MEMORANDUM

Response to Appeal (APP 2020-003)

West Sylvan Middle School Field Improvements (CU2019-0011 / DR 2019-0182)

Figure 1. PA Systems Sounds Distribution.
(Source: PA Sound System Study, Application Exhibit I)

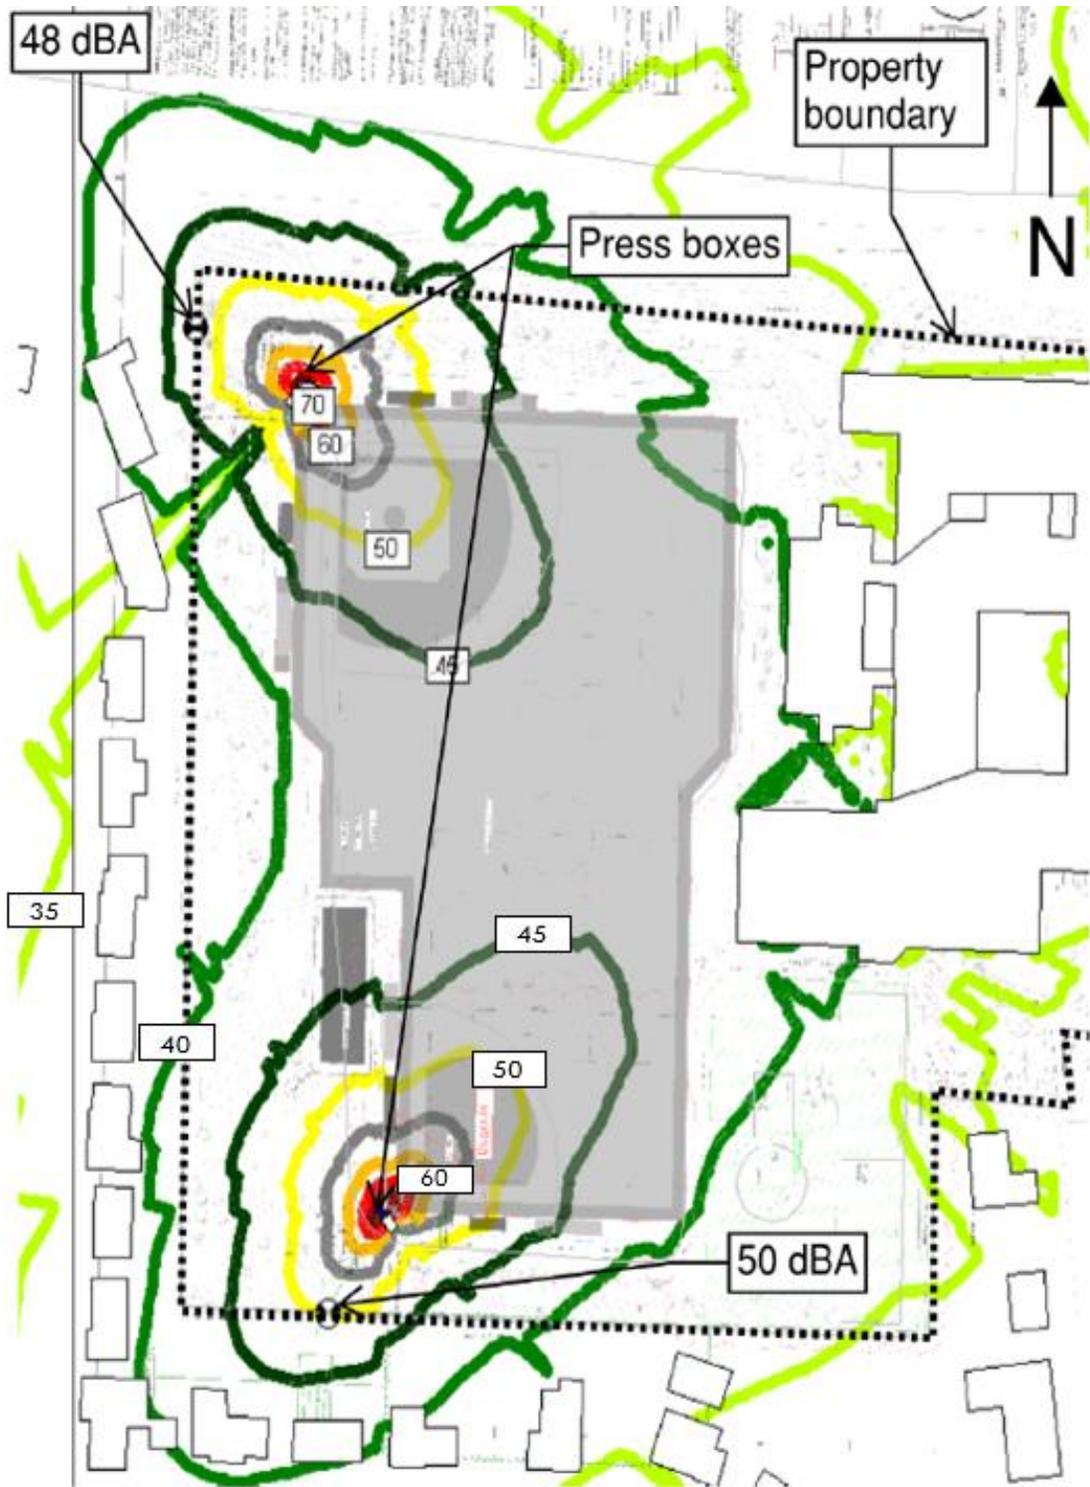
The Appellant's also raised concerns regarding the Portable Public Address (PA) System. The applicant submitted an Acoustical Analysis (Application Exhibit I - with our original application. This analysis was completed by a certified acoustician (Adam C. Jenkins, PE, INCE Bd. Cert. Principal, The Greenbusch Group, Inc.) and addresses concerns raised by the appellant. They include:

- The Acoustical Analysis specifically analyzed the Portable PA System Sound System under conditions where two PA's are used at the same time. Both PA systems, when in use, will be directed away from houses to the west and south of the fields. They will be used only during official athletic events – they will not be available for use during practices. Per the Acoustical Analysis, predicted PA system sound levels do not exceed 50 dBA at neighboring property lines, as shown in Figure 1, which satisfies and is under the 55-dBA limit for commercial noise sources under Oregon Administrative Rules (OAR) 340-035-0035, with the conservative condition of two systems operating at the same time. The PA's will be set and monitored at specific levels to not exceed the levels recommended in the Acoustical Analysis.

- Based on the Acoustical Analysis findings, there will be no noise impacts if operational sound levels of the Portable PA System do not exceed 80 dBA five feet from the front of the PA system. To achieve this sound level, PPS will establish programming and practices requirements in the school's Operations Plan¹ that will provide instruction on the use of and noise level settings on the PA system. Additionally, a Condition of Approval (COA) included in the Planning Commission decision, restricts all amplified sounds, with the exception of the portable PA system (Land Use Order No. 2750 COA #6).

- In response to the concerns raised by the Appellant of wind impacts on noise travel, the noise model used by the certified Acoustical Engineer to predict PA system sound levels in the Acoustical Analysis, included a moderate downwind condition. This is a default condition of the acoustic computation algorithm (ISO 9613 Part II) due to uncertainty of weather conditions, which assumes a moderate downwind condition, in all directions, away from the noise source.

Figure 4. Screening and Buffering Standard Compared to Proposed Design (consistent with Design Guidelines)

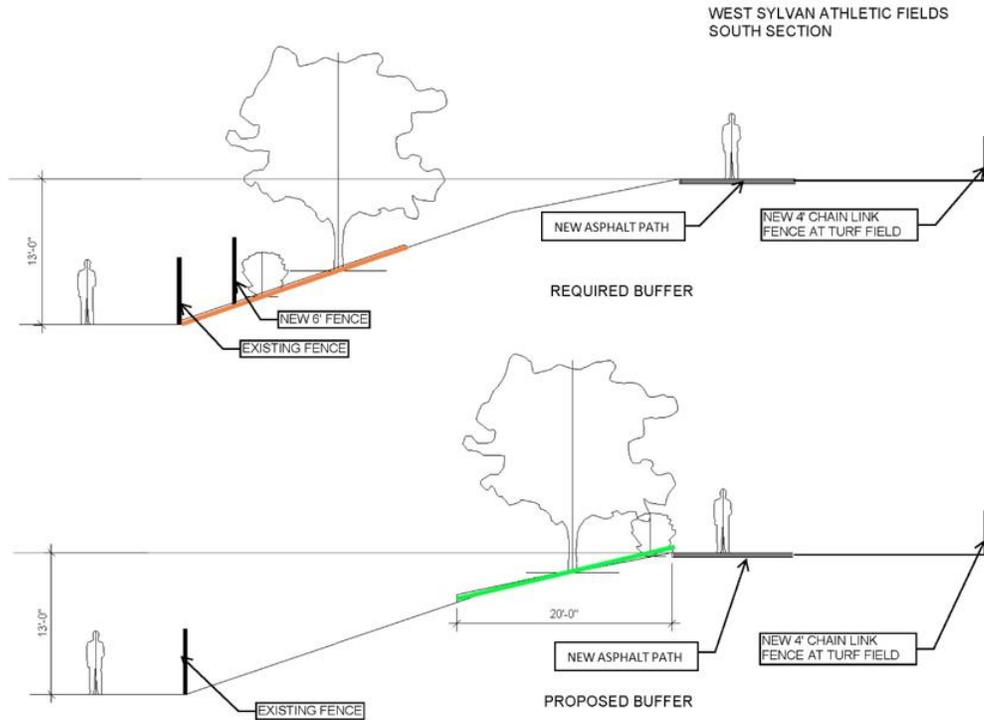
Applicant Response: The appellant has suggested that the screening requirements associated with the proposed development were waived during the review process. That is incorrect. Rather, the applicant has applied and complied with the City’s Design Review Guidelines for screening and buffering. The Design Review Three application filed allows for compliance with Design Review Guidelines, rather than Design Review Standards. The applicant has met the corresponding Design Review Guideline to the B3 buffer standards of BDC 60.05.25.13.D. The guideline, BDC 60.05.45.11, states the following:

Given the topography of the site, the landscape buffer was moved to the top of the hill, consistent with BDC 60.05.45.11.D. As shown in Figure 4 (below), the alternative design provides better screening for properties abutting the site. The landscape buffer, approximately 20 feet in depth, will consist of a variety trees, shrubs, ground cover, and grasses. See the Landscape Plan (Application Exhibit A, Sheet L100) for more information. Additionally, for the landscape buffer PPS will add evergreen trees, and shrubs that are a minimum of 36 inches tall and will reach 90-percent opacity within three years of planting, as applied in a Conditions of Approval adopted by the Planning Commission (Land Use Order No. 2750 COA #12). See pages 45 to 47 of the original application narrative for complete responses to the Design Guidelines.

Moving the southern buffer to the top of the hill was in response to comments made by neighbors who attended the first Neighborhood Meeting, held on August 6, 2019. At this meeting neighbors suggested they would prefer to have screening and buffering moved upslope to increase sight-obstruction onto neighboring properties as recorded in the meeting minutes (Application Exhibit C) sent to the NAC Chairman on September 5, 2019.
